Crestline

62900 – 92910 / 62990 - 62999

**ISSUE:** Suction unit upgrade to disposable canisters.

**ACTION:** Replace existing suction unit with supplied upgrade unit.

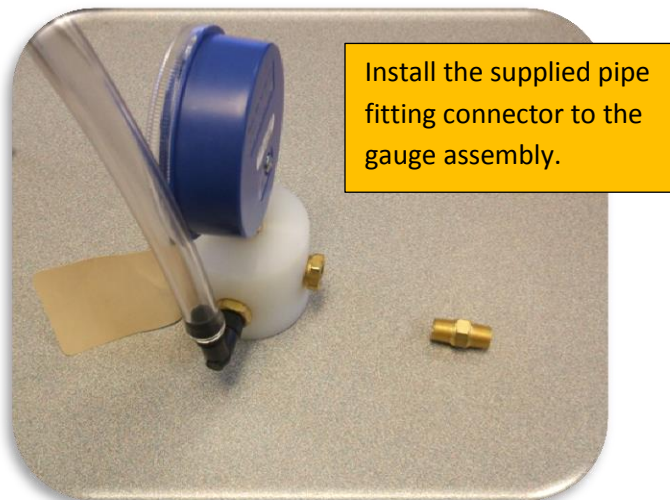
- 1) Remove existing suction unit and discard.

Remove the suction hose from the wall fitting.

Remove the canister by unscrewing the thumb screw.

Remove 90° fitting.

Remove the 4 screws.

## 2) Install new suction unit.

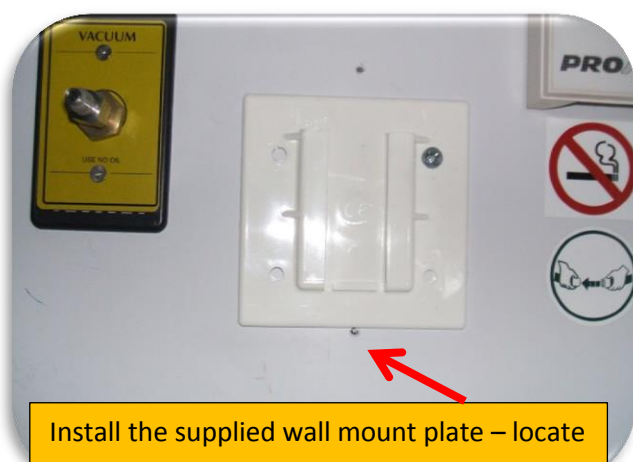
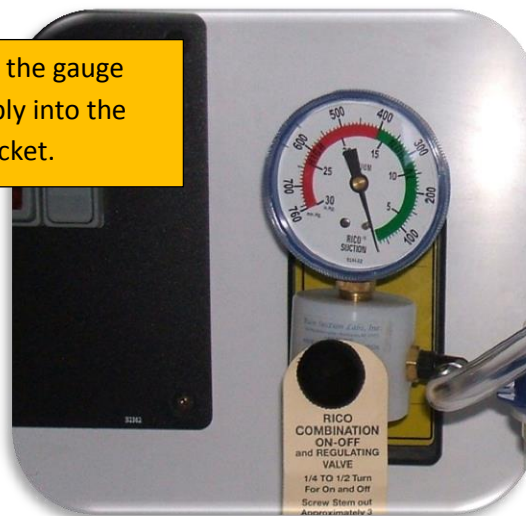
Thread the gauge assembly into the wall socket.

Install the supplied wall mount plate – locate the plate just above the bottom hole – use the wall mount plate as template to drill the screw holes – install the supplied screws.

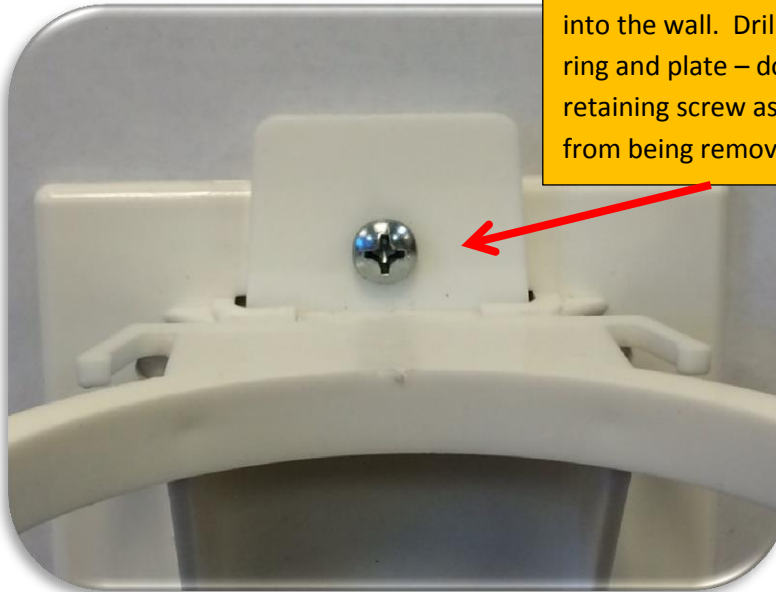
Drill a 1/8" pilot hole through the mount ring and into the wall. Drill a 7/32" hole through the mount ring and plate – do not drill into the wall. Install the retaining screw as shown. This will prevent the ring from being removed with the canister.

Install the new canister into the mounting ring.
